TI 1104 – Gas pipe inspection notice

MACHINES AFFECTED: Dryer models: TD30, TD50, TD75 (gas heated only).

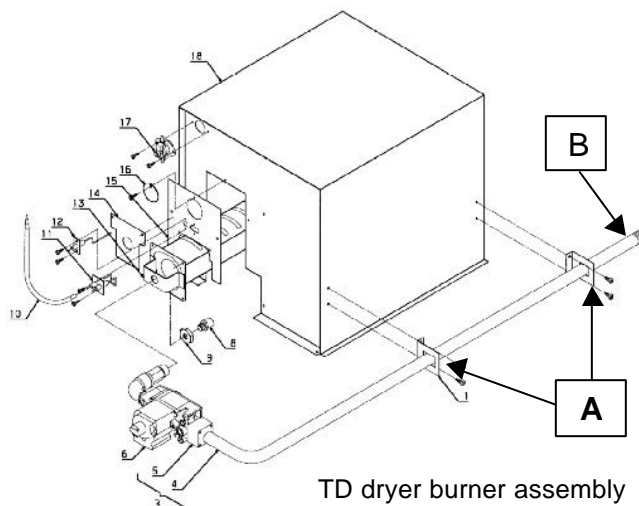
On the above referenced models, it is possible for the gas-pipe support brackets on the right side of the burner compartment (viewed from the front) to rub against the gas pipe, causing a wear groove to develop in the pipe due to normal machine vibration.

Dealers and owners are instructed to conduct an immediate visual inspection at two points “A” (where the gas pipe is supported by the two brackets), and point “B” (where the gas pipe passes through the back panel of the dryer).

If grooves are found on the gas pipe, turn off the gas supply and the electrical service to the machine, placing it out of service, and contact Wascomat’s Technical Support department at 516-371-0700 for further instructions.

Note that some small scratches and / or wear marks on the gas pipe are normal.
